ATTACHMENT 1

PROPOSED TECHNICAL SPECIFICATIONS CHANGES
NORTH ANNA UNIT 1

VIRGINIA ELECTRIC AND POWER COMPANY

DISCUSSION OF PROPOSED CHANGES

Figure 2.1-1a REACTOR CORE SAFETY LIMITS FOR THREE LOOP OPERATION FOR THE PERIOD OF OPERATION UNTIL STEAM GENERATOR REPLACEMENT

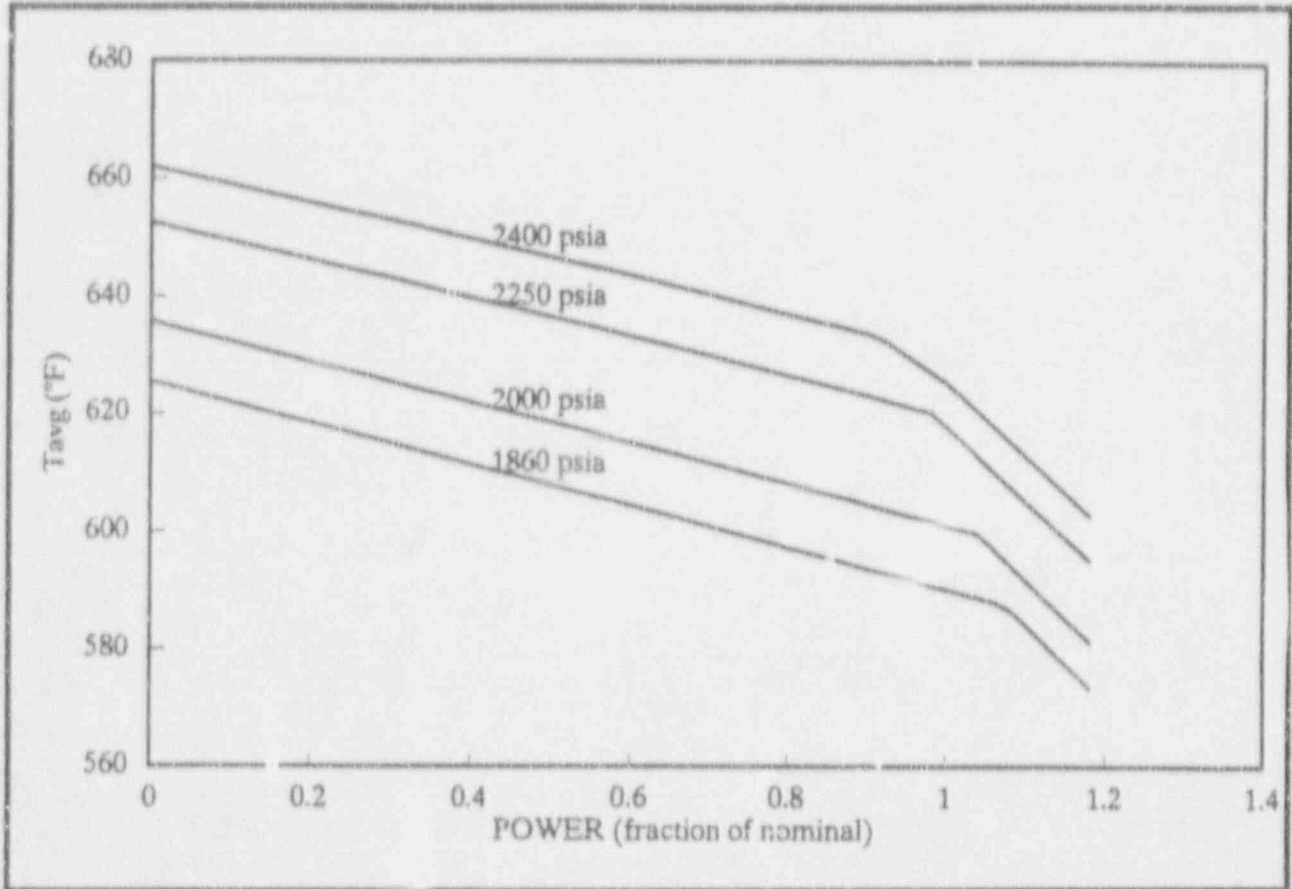
* For the period of operation until steam generator replacement, the combination of THERMAL POWER, pressurizer pressure, and the highest operating loop coolant temperature (T_{avg}) shall not exceed the limits shown in Figure 2.1-1a.

The proposed Technical Specifications changes will revise Technical Specification 2.1.1 by placing a footnote on the bottom of the page referencing Figure 2.1-1a in lieu of Figure 2.1-1 for the Reactor Core Safety Limits. A revised reactor core safety limits graph (Figure 2.1-1a) is added with the inclusion of a new page - 2-2a. The graph is changed to reflect the 268,500 gpm flow limit at 95% of Rated Thermal Power. Both the footnote and the graph title are worded to be effective for the period of operation until steam generator replacement.

FIGURE 1
CORE THERMAL LIMITS

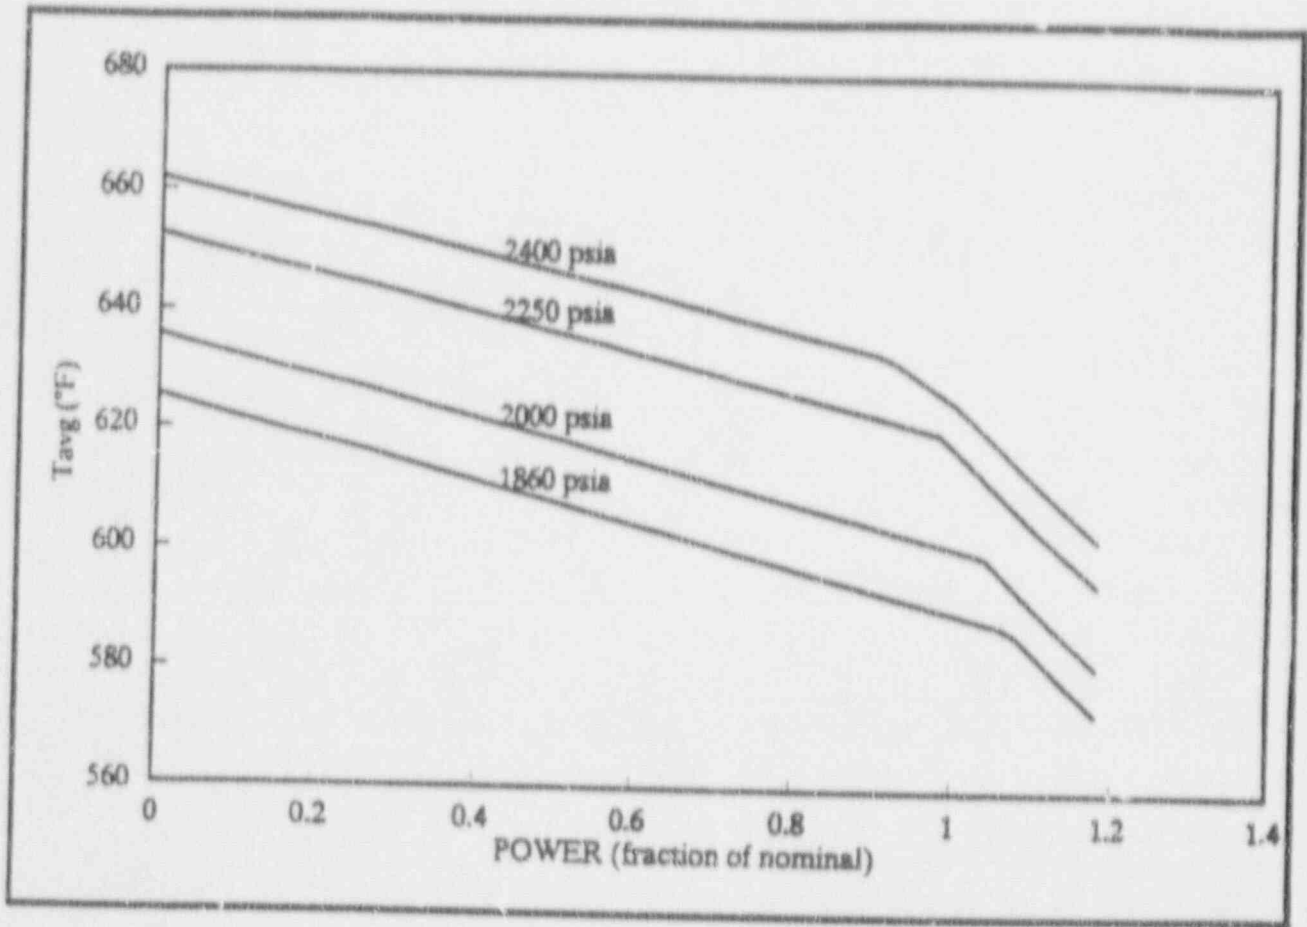
For the proposed additional reduction in minimum measured RCS flow rate to 268,500 gpm, revised thermal limit lines have been generated based on this reduced flow and a design DNBR limit of 1.46. In this way, no flow reduction penalty need be assessed against the generic retained DNBR margin for operation at 268,500 gpm. The definition and application of retained DNBR margin in Virginia Power design analyses is described in References 1 and 2.

The vessel exit boiling limited portions of the core thermal limits were evaluated with the proposed reduced non-statistical (deterministic) thermal design flow rate of 263,130 gpm (which corresponds to a minimum measured flow rate limit of 268,500 gpm). The revised Thermal Limits are shown in Figure 1.

FIGURE 2

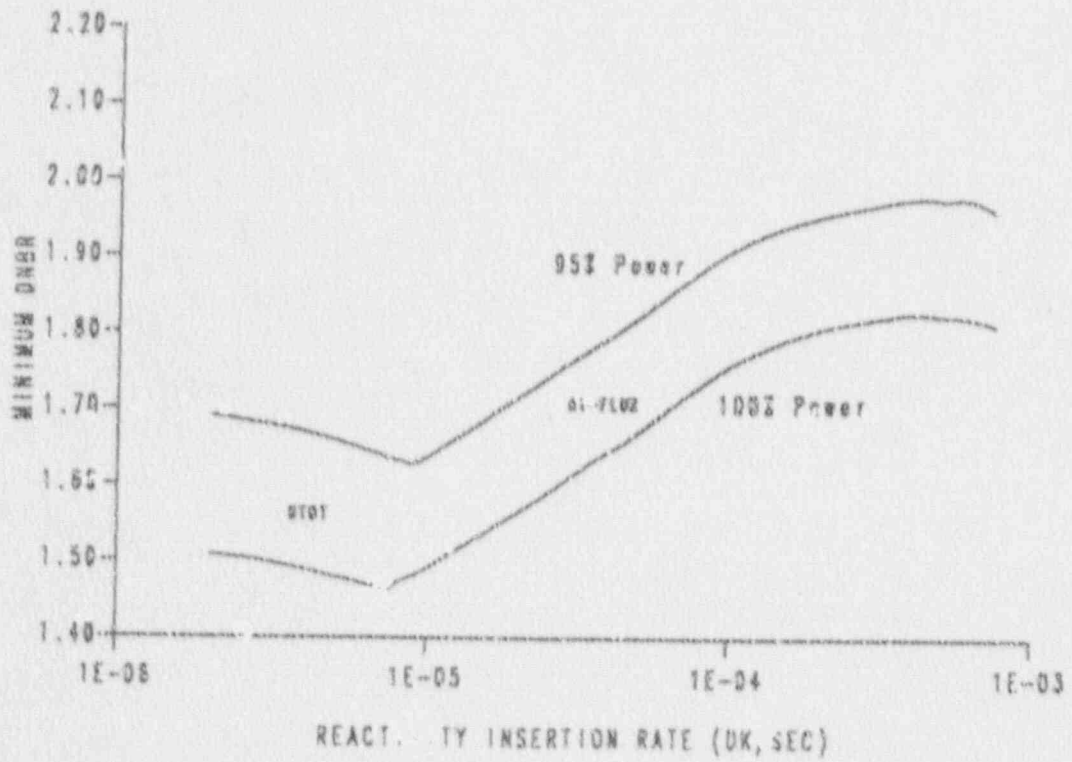
The reanalysis of the rod withdrawal at power event demonstrated that the minimum DNBR will remain above the DNBR design limit for operation with reduced minimum measured flow associated with extended steam generator tube plugging.

Figure 2, on the following page, presents the minimum RWAP DNBR result as a function of reactivity insertion rate. The lower graph (labelled 100% Power) shows the Ref. 1 analysis results assuming the 275,300 gpm minimum measured flowrate, 100% power and the current Technical Specification OTAT setpoints. The upper graph (labelled 95% power) shows the results from the revised analysis with reduced minimum measured flowrate, 95% power, the proposed Technical Specification OTAT setpoints, and a reduction in the power range high flux trip setpoint. These results demonstrate that the combination of Overtemperature ΔT and high flux reactor trips act together to provide core DNB protection over the range of achievable thermal conditions.
